SYDNEY CENTRAL CITY PLANNING PANEL

Panel Reference	2017SWC140
DA Number	DA 318/2010/JP/E
LGA	The Hills Shire Council
Proposed Development	Section 4.55(2) modification to an approved staged warehouse development
Street Address	Lot 2 DP 251094 Mile End Road, Rouse Hill
Applicant/Owner	Full Tilt Constructions P/L/N and D Shedden
Date of DA lodgement	17 November 2017
Number of Submissions	None
Recommendation	Approval
Regional Development Criteria (Schedule 7 of the SEPP (State and Regional Development) 2011	Section 4.55(2) Modification Applications requires determination by the Sydney Central City Planning Panel
List of all relevant s4.15(1)(a) matters	<ul style="list-style-type: none"> • SEPP (State and Regional Development) 2011 • SEPP No. 55 – Remediation of Land • SREP No. 20 – Hawkesbury Nepean River • The Hills DCP Part B Section 7 – Industrial • DCP Part C Section 1 – Parking • DCP Part C Section 2 – Signage • DCP Part C Section 3 - Landscaping

EXECUTIVE SUMMARY

APPROVED SIGN

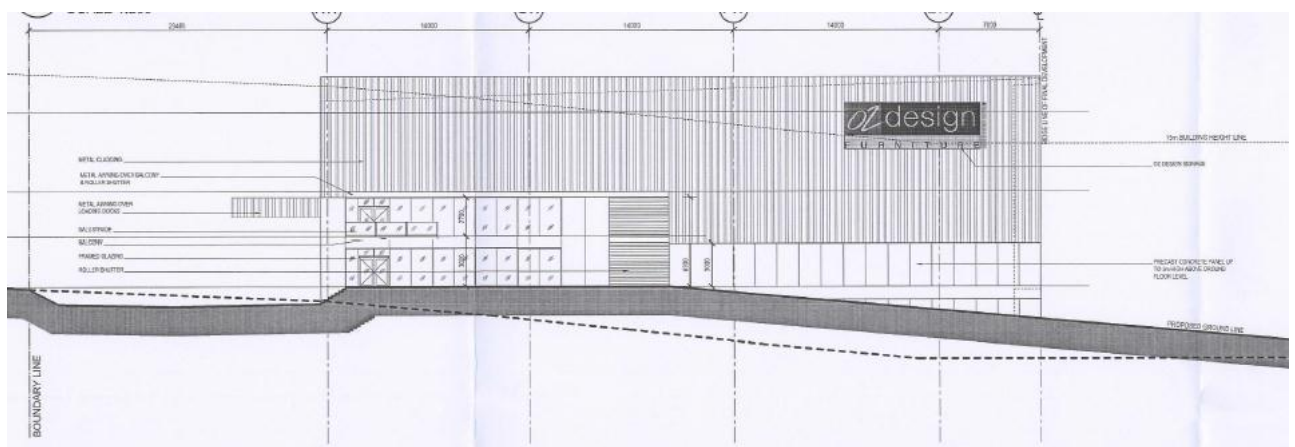
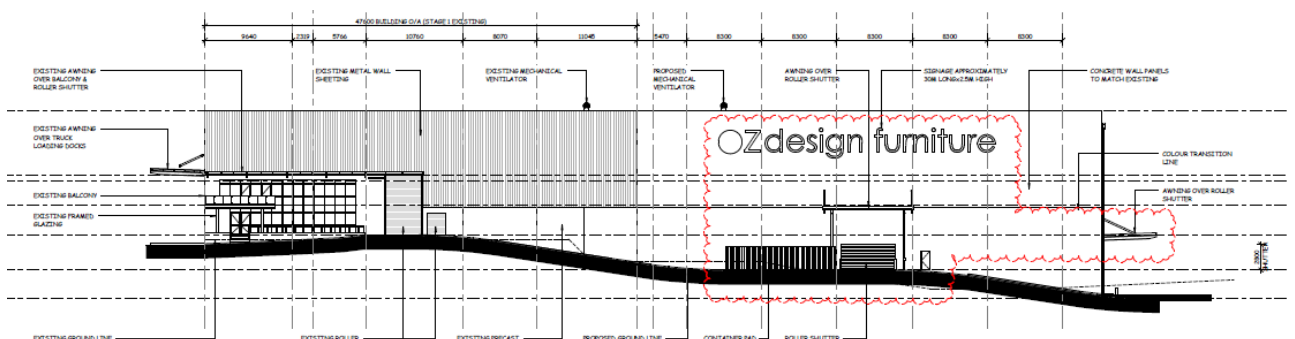
The proposed modification to the approved signage on the eastern elevation has been assessed against the relevant development standards within DCP Part C Section 2 – Signage and it complies with the exception of the following:-

The proposal includes a signage area variation. Pursuant to the signage DCP, a maximum of 0.5m² per one metre length of the building is permitted. The maximum signage permitted

is 49.1m² due to the 98.2m building length of the eastern façade. The proposed sign includes dimensions of 30m x 2.5m resulting in a total area of 75m².

The variation is considered satisfactory as the signage is proportionate to the size and scale of the building. The nature of the proposed signage will not be inconsistent when compared to the scale of the building and with the sign approved under the original consent as shown below:

The variation is predominately due to the proposed spacing and gaps between the proposed lettering of the corporate branding. The sign is not offensive within the streetscape due to the generous front setback of the proposed development. The variation to façade signage is considered satisfactory as it will be able to adequately identify the business to be conducted.
